APPARATUS AFFECTED: DATASPEED 40 Logic Cabinets 40CAB201/AB and 40CAB251/AB.
DATASPEED 40 Pedestals 40CAB901/AA, 40CAB901/AB, 40CAB901/AF and 40CAB901/AG.
TP401040 Ventilation Assembly.

PART AFFECTED: TP401038 Fan Panel
TP401045 Motor Pinion
TP401046 Fan Assembly

REASON: To reduce wear of the sprocket teeth on the fan w/pulleys and the motor pinion.

TELETYPEWRITER CHANGE NOTICE
TCN 2085 Issue 1 June, 1975

NEW-STYLE TP401038 FAN PANEL

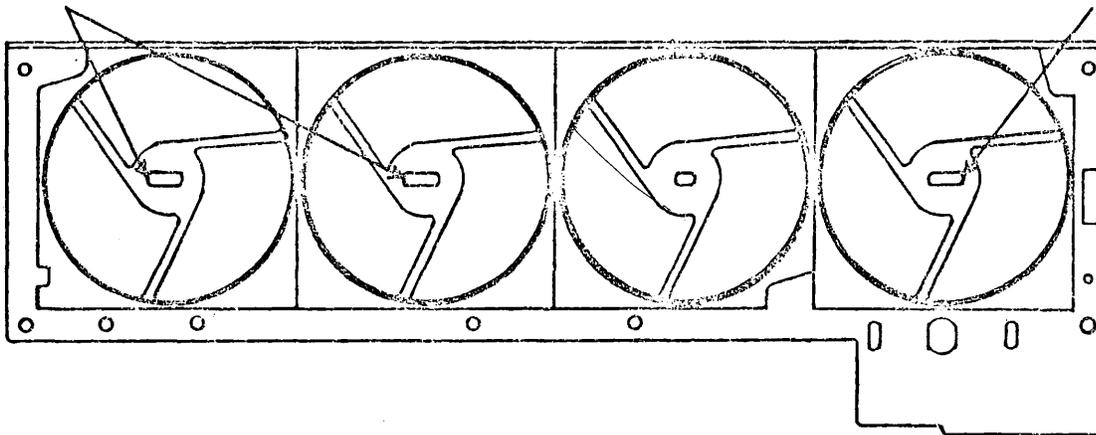
(1A) The TP401038 fan panel is redesigned by elongating three of the four fan assembly mounting slots by approximately 1/8-inch. See Attachment Sheet 1 for illustration of this change.

The old-style TP401038 fan panel has three 3/8-inch long fan assembly mounting slots. The new-style TP401038 fan panel has three 1/2 inch long fan assembly mounting slots. See Attachment Sheet 1.

**THESE TWO MOUNTING SLOTS
ELONGATED APPROX. 1/8-INCH
AT THIS END OF SLOT.**

**THIS MOUNTING SLOT
ELONGATED APPROX. 1/8-INCH
AT THIS END OF SLOT.**

**NOTE: BEFORE ASSEMBLING THE NEW-STYLE TP401048
FAN ASSEMBLIES TO AN OLD-STYLE TP401038 FAN
PANEL (ON WHICH THE THREE MOUNTING SLOTS ARE
3/8-INCH LONG), THE THREE MOUNTING SLOTS SHOULD
BE ELONGATED APPROXIMATELY 1/8-INCH AT THE END
OF THE SLOT INDICATED ABOVE.**

PART OF TP401010 VENTILATION ASSEMBLY

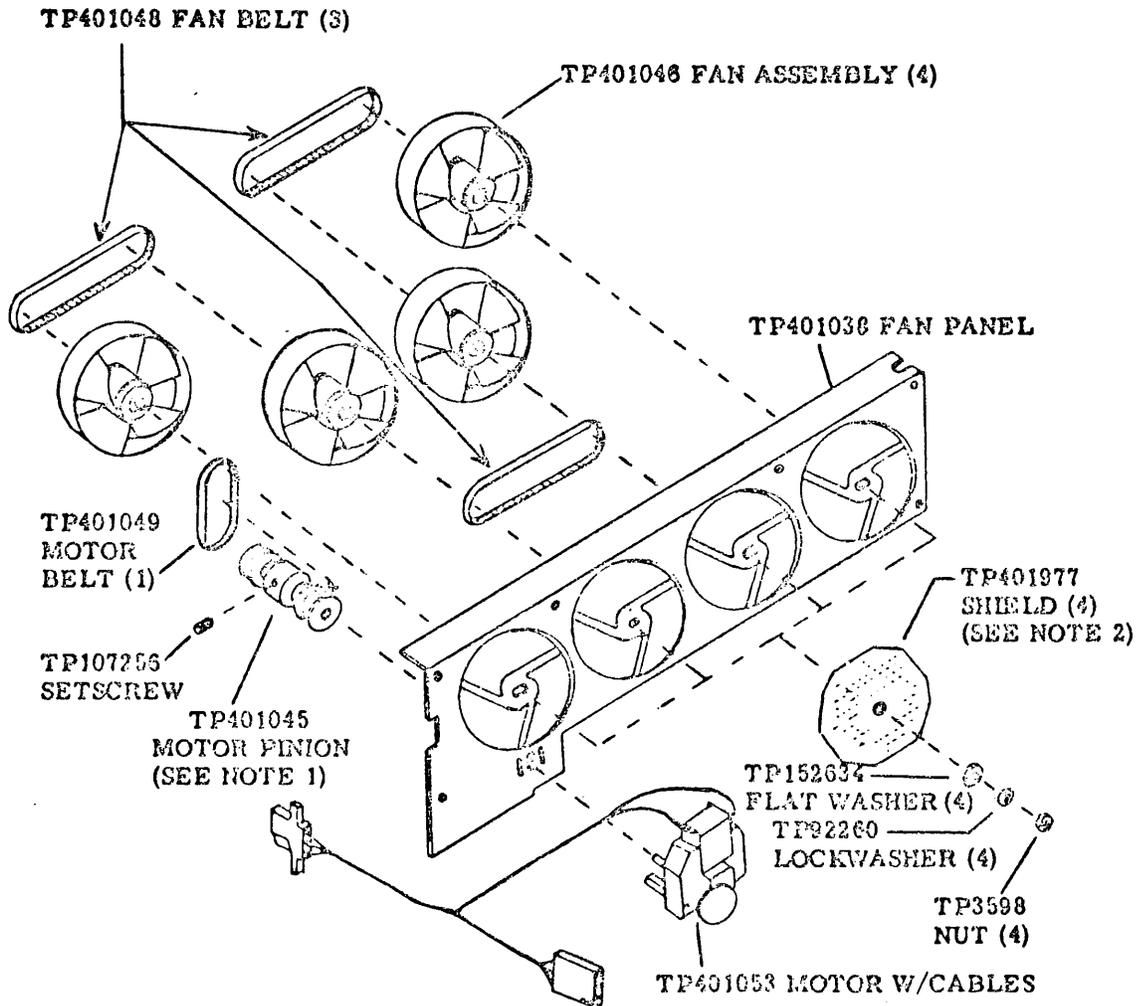
(1B) The material of the TP401045 motor pinion is changed from A.B.S. plastic (black) to nylon (white or natural).

(1C) The material of the fan w/pulleys (part of the TP401046 fan assembly) is changed from A.B.S. plastic (black) to nylon (white or natural). Four TP401046 fan assemblies are used on the TP401040 ventilation assembly.

See Attachment Sheet 2 for illustration of the parts involved in this change and the method of assembly.

NOTE 1 - THE SMALLER DIAMETER PULLEY ON THE TP401045 MOTOR PINION IS FOR 60 HERTZ OPERATION AND THE LARGER DIAMETER PULLEY IS FOR 50 HERTZ OPERATION. PULLEY FOR DESIRED OPERATION SHOULD BE ATTACHED NEAREST TO FAN MOTOR.

NOTE 2 - TP401977 SHIELDS ARE ASSEMBLED WITH CONCAVE SIDE TO FAN PANEL.

BELT ADJUSTMENTS

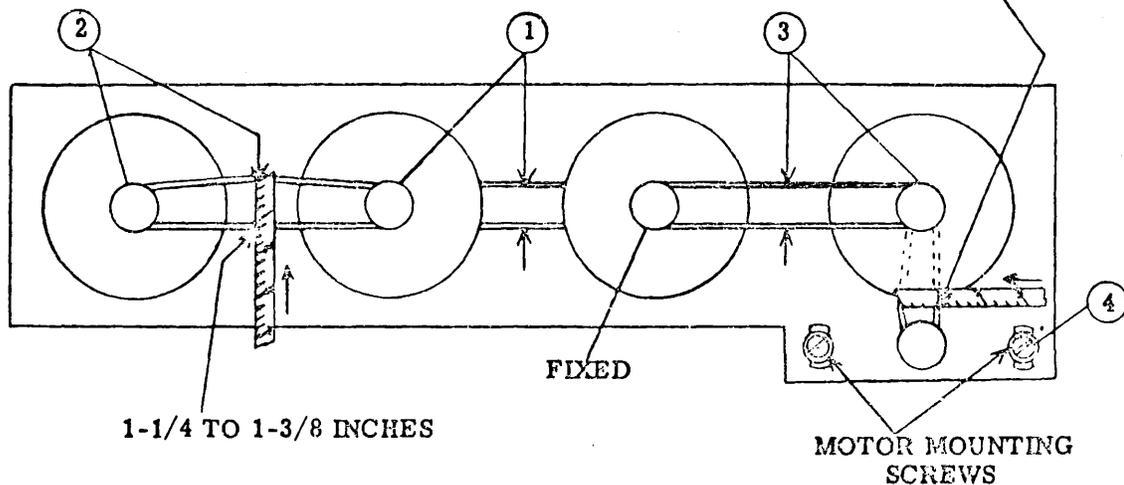
The applicable ventilation assembly adjustments are shown on Attachment Sheets 3 and 4. (The belt adjustments are new.)

REQUIREMENT FOR TP401048 FAN BELTS (THREE)

Distance from inside of belt (between teeth) to outside of belt should be
Min 1-1/4 inches ---- Max 1-3/8 inches

when belt is deflected midway between fans to just take up play using a small steel rule. Caution must be exercised not to force belts enough to bend fans toward each other on their mounting posts.

REQUIREMENT FOR TP401049 MOTOR BELT

Distance from inside of belt (between teeth) to outside of belt should be
Min 11/16-inch --- Max 13/16-inch (60 HZ operation)
Min 3/4-inch --- Max 7/8-inch (50 HZ operation)

Fan assembly mounting nut friction tight. Position fan assembly in its slot to right or left to meet requirement. Tighten nut.

when a small steel rule is held flat against lower periphery of fan and belt is deflected by the rule to take up play. Caution must be exercised not to force belt more than is required to snugly take up play.

Motor mounting screws friction tight. Position motor up or down in its slots to meet requirement. Tighten screws.

MOTOR PINION ADJUSTMENT

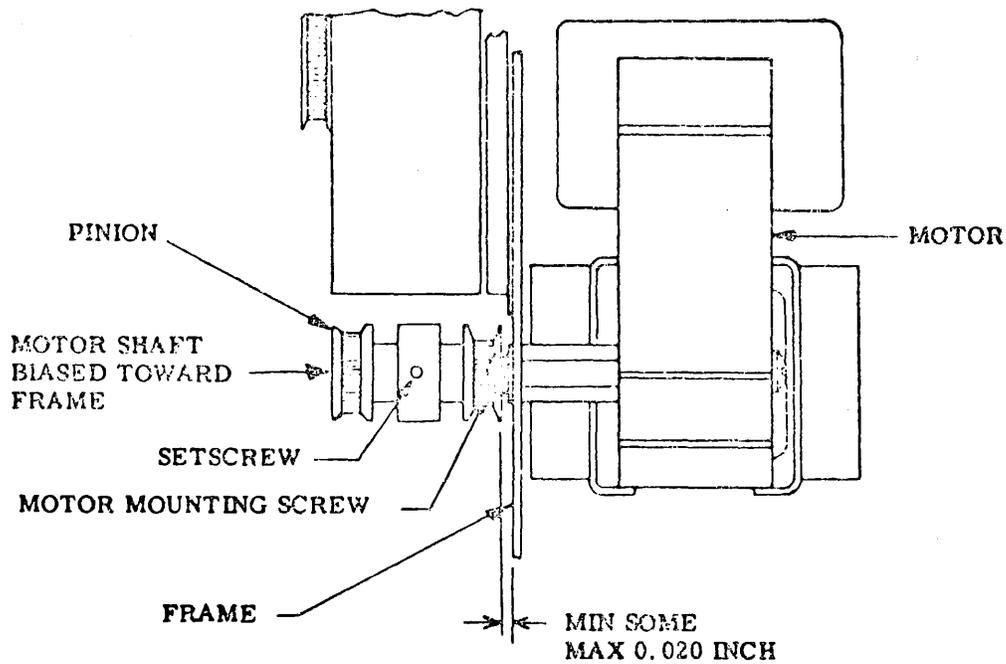
REQUIREMENT

MIN SOME ---- MAX 0.020 INCH
BETWEEN PINION FLANGE AND FRAME
WHEN PINION END OF MOTOR SHAFT IS
BIASED TOWARD FRAME.

LOOSEN PINION SETSCREW. POSITION PINION TOWARD OR AWAY FROM FRAME TO MEET REQUIREMENT. TIGHTEN SETSCREW. CHECK FOR BINDS BETWEEN PINION FLANGE AND FRAME.

LUBRICATION REQUIREMENT FOR VENTILATION ASSEMBLY

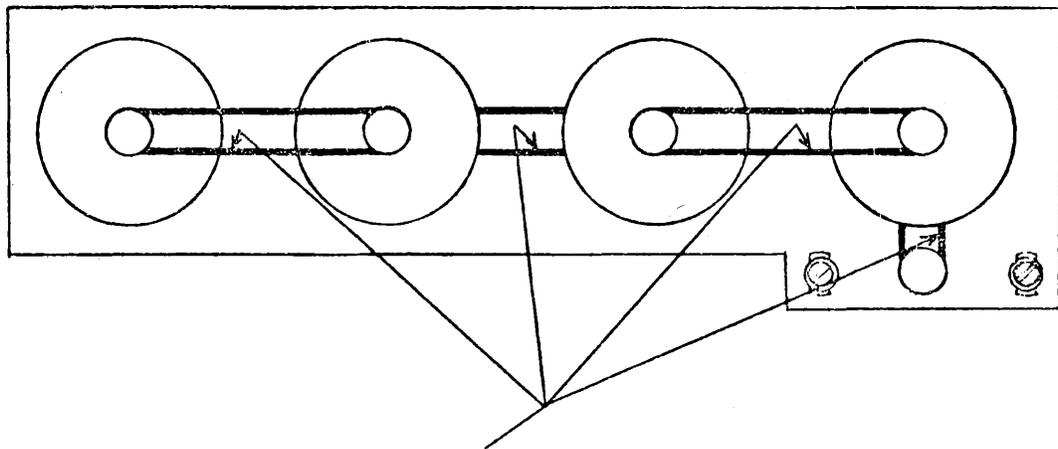
The lubrication requirement for the ventilation assembly is shown on Attachment Sheet 5.

APPLY A THIN FILM OF KS-7471 GREASE TO THE TEETH OF THE TP401048 FAN BELTS AND TP401049 MOTOR BELT, USING A BRUSH. MANUALLY ROTATE FAN WHILE APPLYING GREASE. AFTER VENTILATION ASSEMBLY HAS BEEN RUN BRIEFLY, EXCESS GREASE SHOULD BE REMOVED FROM FANS.
